Official Transcript of Proceedings **ACRST-3313**

NUCLEAR REGULATORY COMMISSION

Title: Advisory Committee on Reactor Safeguards
Grand Gulf Application Early Site Permit

Date: Monday, May 16, 2005

Geologic Section B-B'

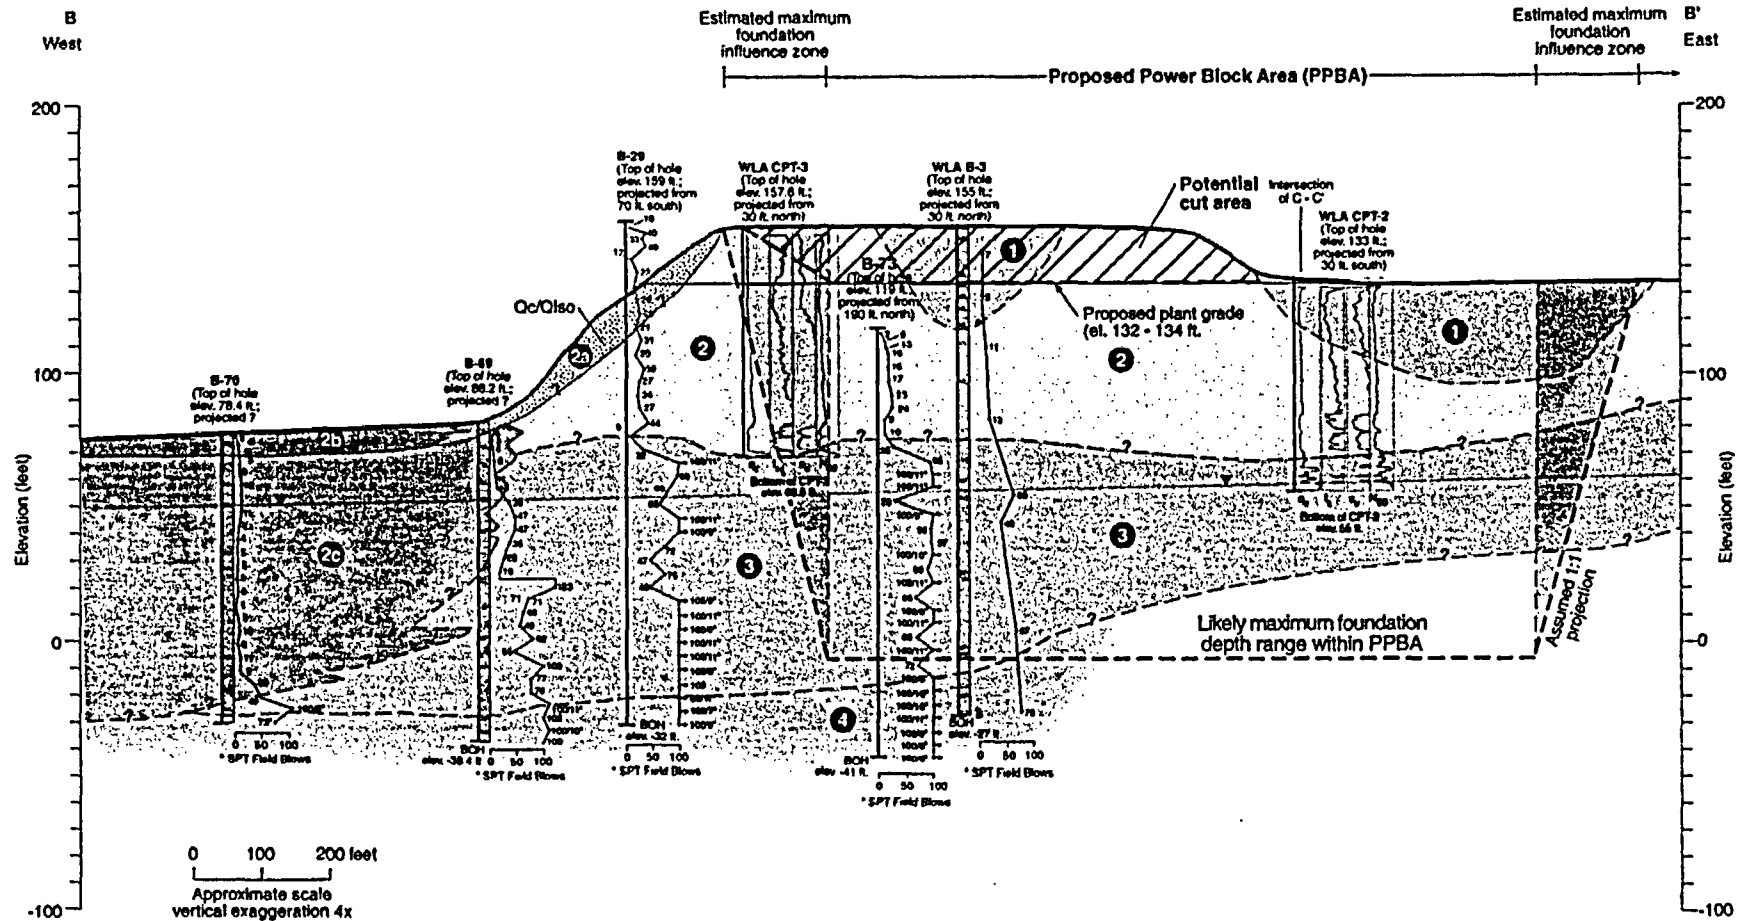
16 MR. HINZE: Jim, I noticed that your cross
17 section, I assume is controlled by your well level
18 control. You are about 30 miles away from the Grand
19 Gulf site. How would that profile change if that were
20 drawn north/south through the Grand Gulf site?

21 MR. HENGESH: It would change very little
22 actually because we are very close to the center --
23 let me back up two slides. We are very close to the
24 center of the Mississippi alluvial valley here. In
25 fact, this line coming down through here shows that
